Report FL #: 10088 for Greenheck models EHH-601D & ESD-635D (both w/ and w/o VCD-40 Damper)

Report FL #: 10093 for Airolite models SCH601MD & K6746MD (both w/ and w/o VCD-40 Damper)

NOTICE OF ACCEPTANCE (NOA)

APPROVAL DOCUMENT: Drawing No. **EHH-601D**, titled "EHH-601D Louver", sheets 1 through 35 of 35, dated 08/09/2017, prepared by Greenheck Fan Corporation, signed and sealed by Wayne K. Helmila, P.E. on 09/27/2024, bearing the Miami-Dade County Product Control revision stamp with the Notice of Acceptance number and expiration date by the Miami-Dade County Product Control Section.

P.O. BOX 410 SCHOFIELD, WISCONSIN 54476-0410	DRAWN BY MES	DATE 8/9/2017
	SCALE	
TITLE EHH-601D LOUVER CONTINUOUS ANGLE MOUNT ELEVATION H≤144"	SHEET NO. 2 OF 35	
	CAD DRAWING NO. EHH-601D

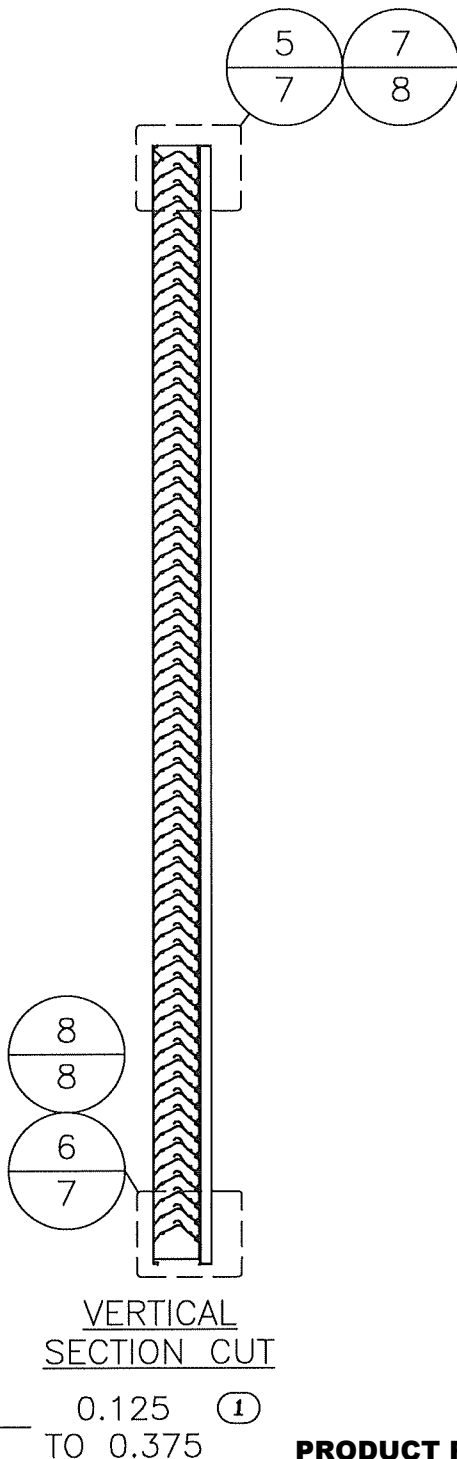
REV 01: 8/1/24, UPDATED TITLE BLOCK & DETAIL TITLES ON ALL PAGES AS NEEDED, UPDATED DETAIL CALLOUT PAGE NUMBERS AS NEEDED ON ALL PAGES, ADDED PRESSURE BOX, ADDED DETAIL CALLOUT NOTES, & REMOVED "TYP" FROM EDGE GAP X4.

GREENHECK P.O. BOX 410 SCHOFIELD, WISCONSIN 54476-0410	DRAWN BY MES	DATE 8/9/2017
	SCALE	SHEET NO. 3 OF 35
TITLE EHH-601D LOUVER W/VCD-40 FLANGE FRAME SLEEVE MOUNT ELEVATION H≤144"

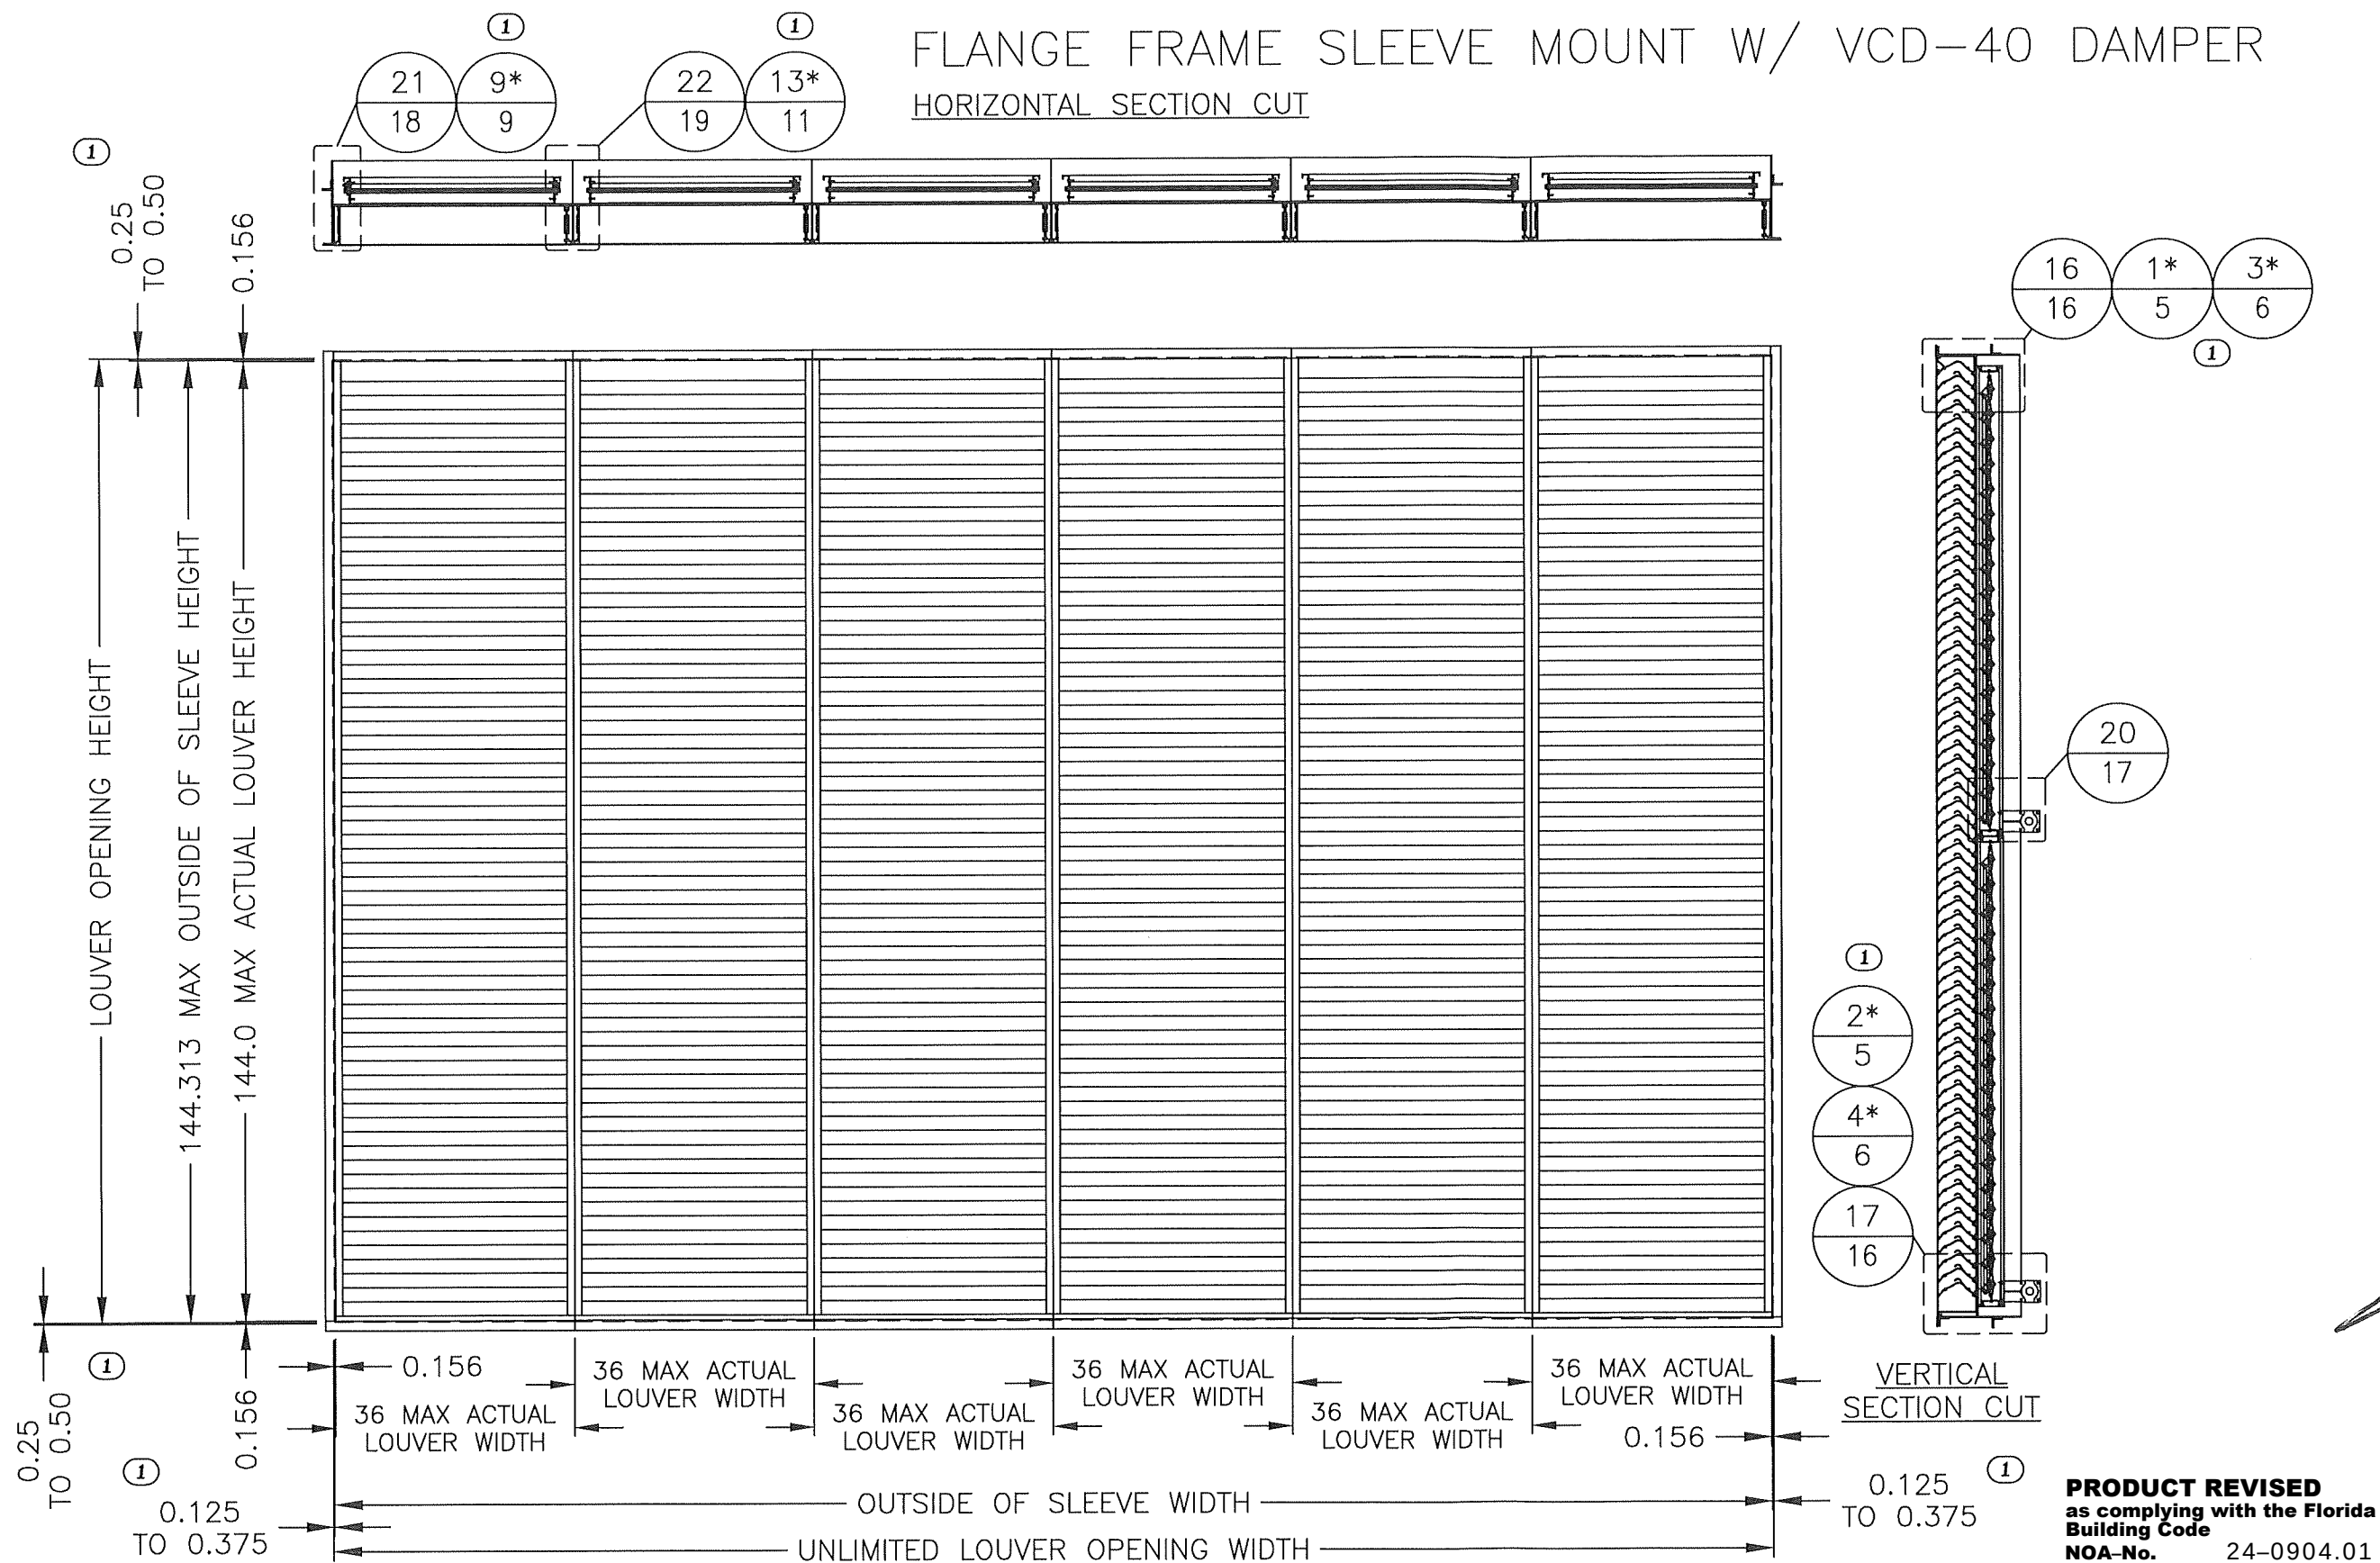
REV 01: 8/1/24, REMOVED "TYP" FROM EDGE GAP X4, ADDED DETAIL CALLOUTS 1/2/3/4/9/13, & ADDED ASTERISK NOTE.

DRAWN BY: MES
DATE: 8/9/2017
SCALE:
SHEET NO.: 6 OF 35
TITLE: EHH-601D LOUVER
FLANGE FRAME SLEEVE MOUNT
HEAD & SILL DETAILS
H≤96"

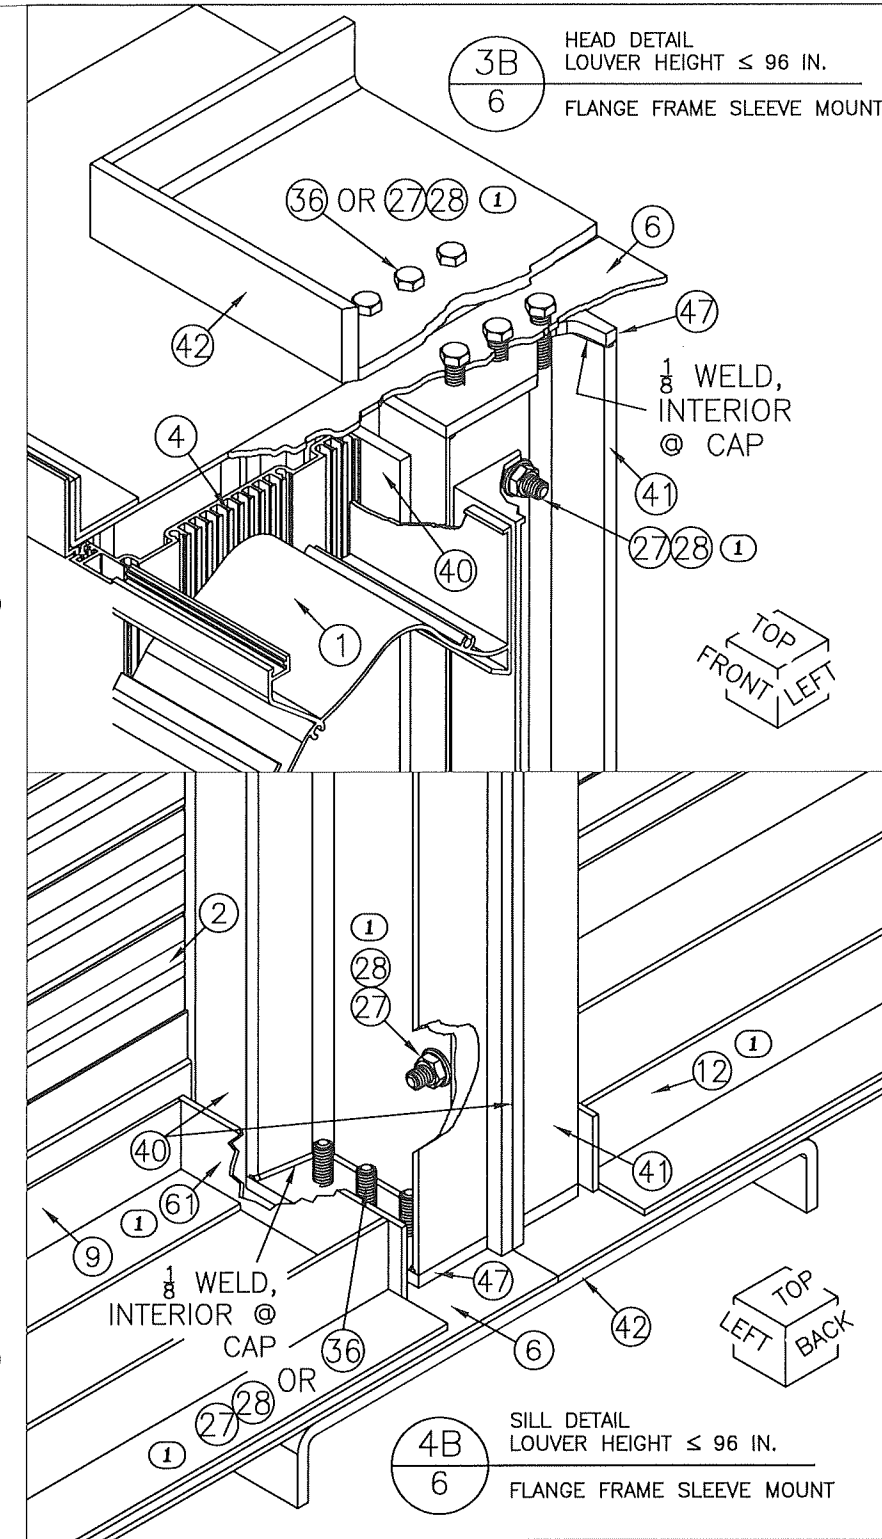
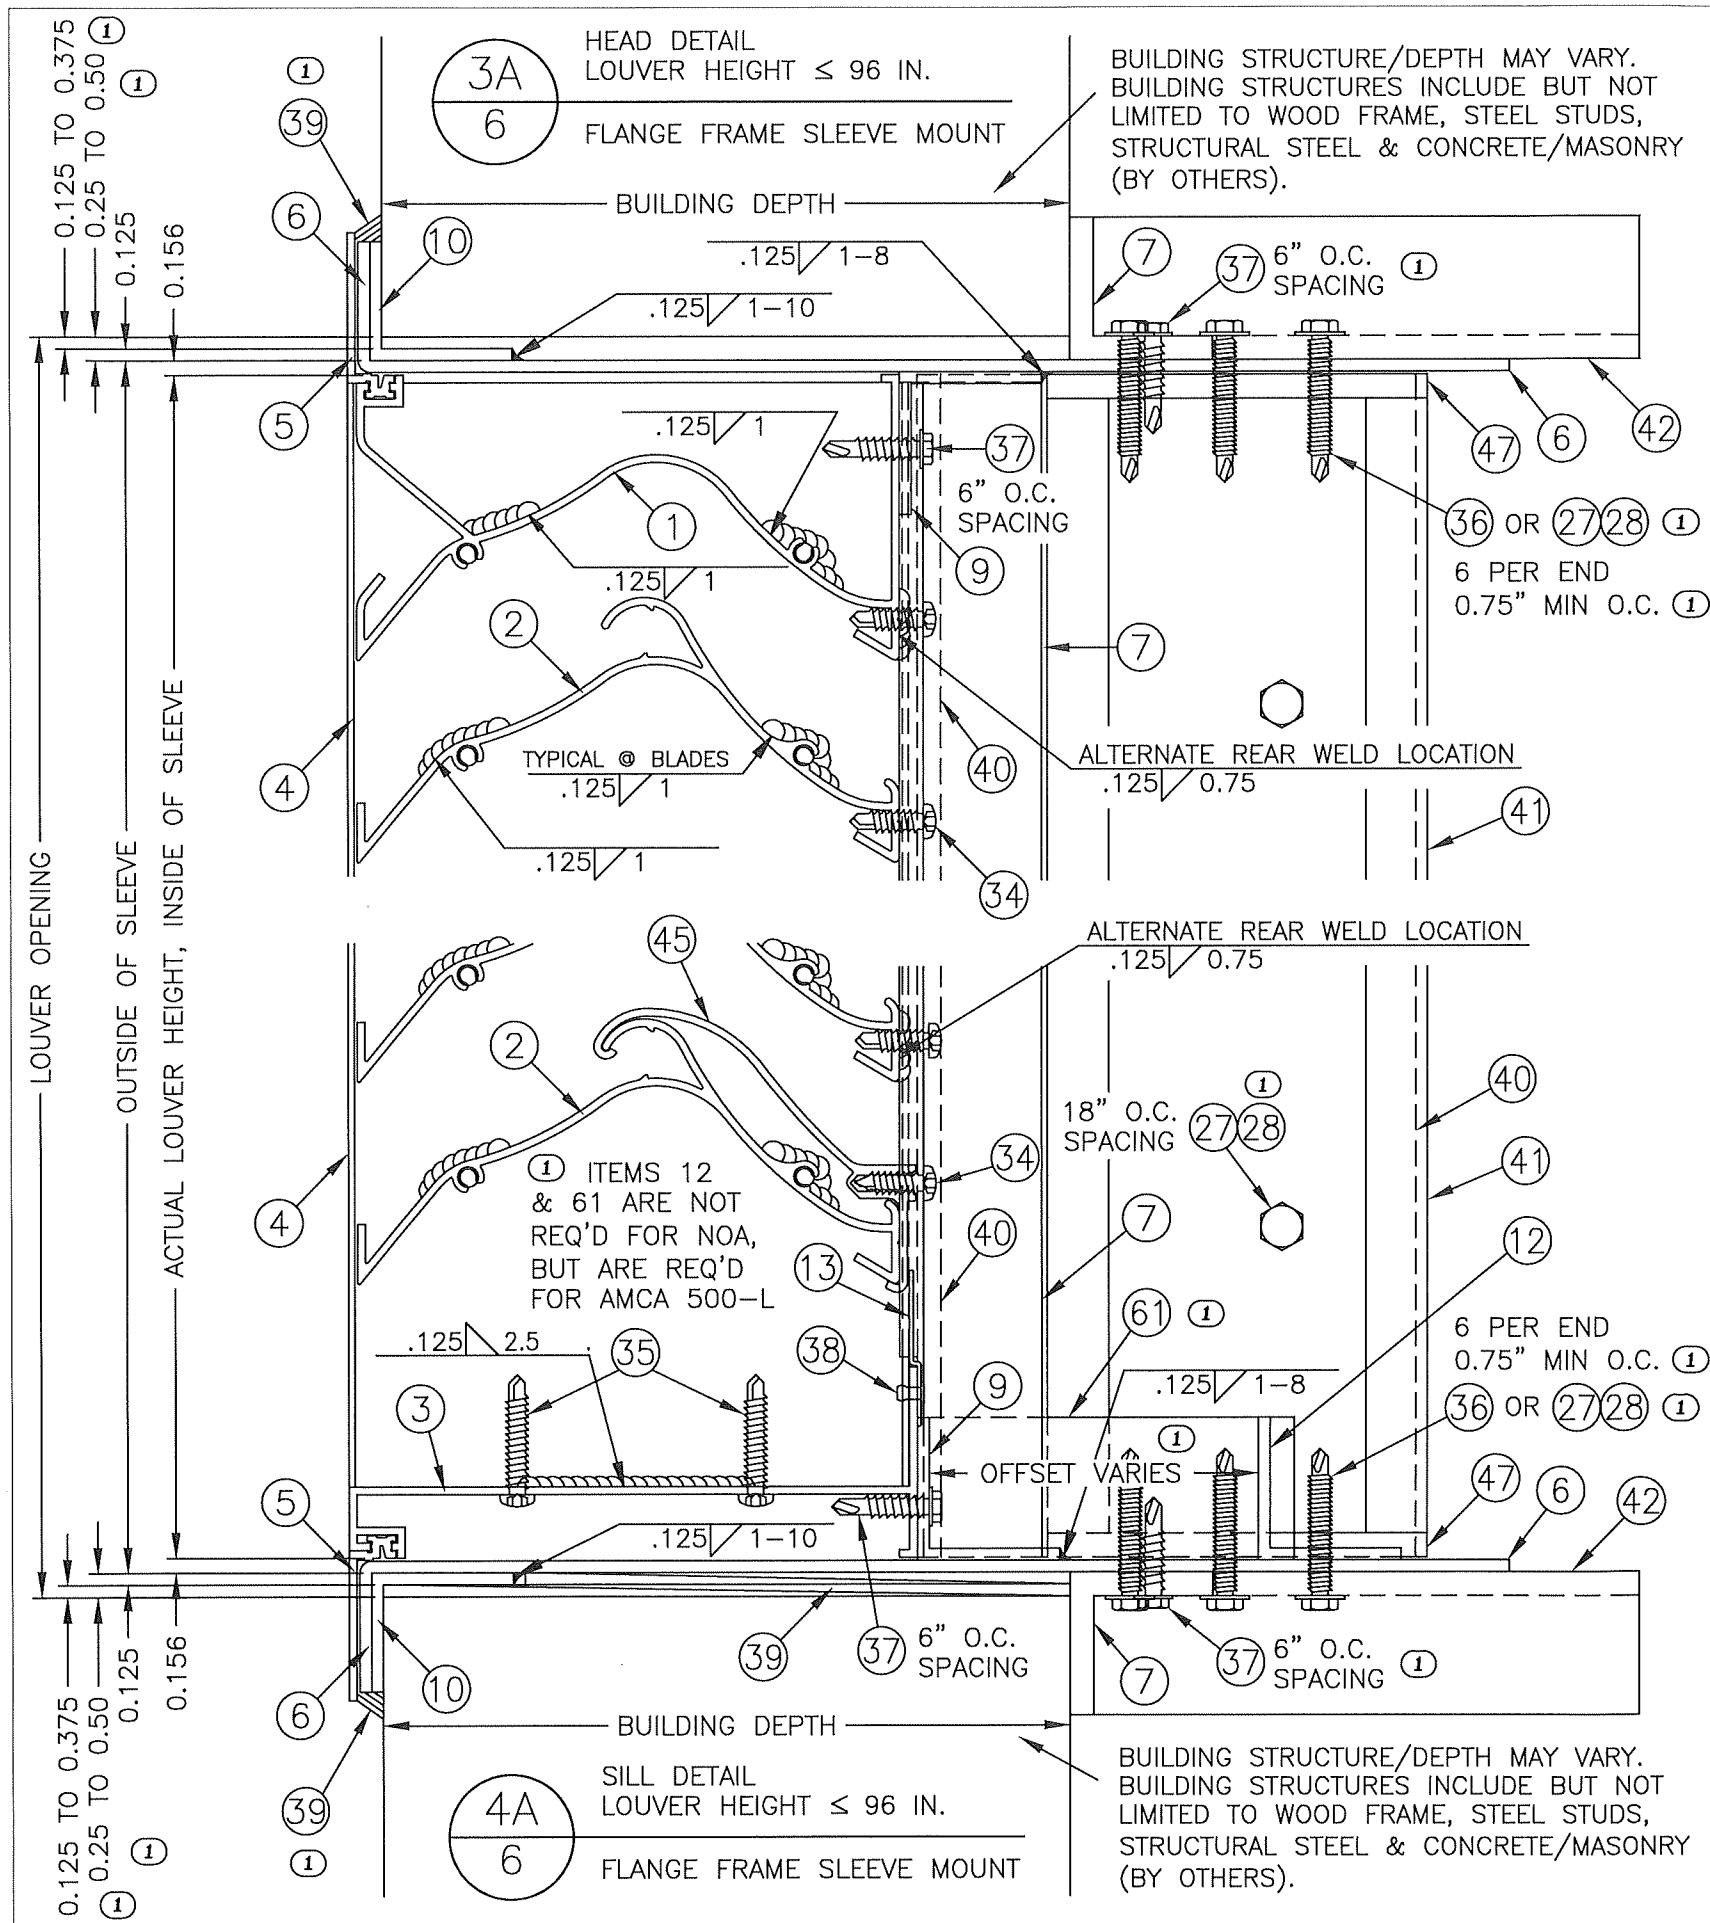
REV 01: 8/1/24, REMOVED "TYP" FROM EDGE GAP X4, ADDED ITEM 39 X2, ADDED MIN O.C. FOR ITEM 36 X2, ADDED ITEM 27 & 28 OPTION X4, ADDED ITEM 37 X2, ADDED CALLOUT FOR ITEM 28 X3, ADDED ITEM 12 OFFSET, ADDED ITEM 1A & 61 NOTE, ADDED ITEM 12 TO 4B & ADDED ITEM 61 TO 4A & 4B.
